# ADA Curb Ramp New Construction Inspection Form (Parallel)

Main 24952.54 Sheet No. Intersection No. Wascoe  
North-South Road Name Project No. East-West Road Name

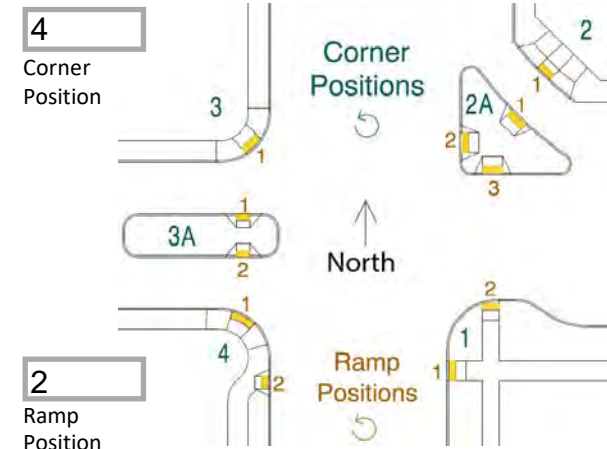
TURN SPACE	Pass	Fail
Width X	5.0 $\geq 4.0'$ <input type="checkbox"/> $< 4.0'$ <input checked="" type="checkbox"/>	
Length Y	6.0 $\geq 4.0'^{*1}$ <input checked="" type="checkbox"/> $< 4.0'^{*1}$ <input type="checkbox"/>	
Back of Ramp Obstruction (Y/N)	Y $\geq 5.0'^{*1}$ <input checked="" type="checkbox"/> $< 5.0'^{*1}$ <input type="checkbox"/>	
Slope X (Cross Slope 1)	1.9 $\leq 2.0\%$ <input checked="" type="checkbox"/> $> 2.0\%$ <input type="checkbox"/>	
Slope Y (Running Slope 1)	1.9 $\leq 2.0\%$ <input checked="" type="checkbox"/> $> 2.0\%$ <input type="checkbox"/>

Comments:  
IITD gt2. Vert drop.
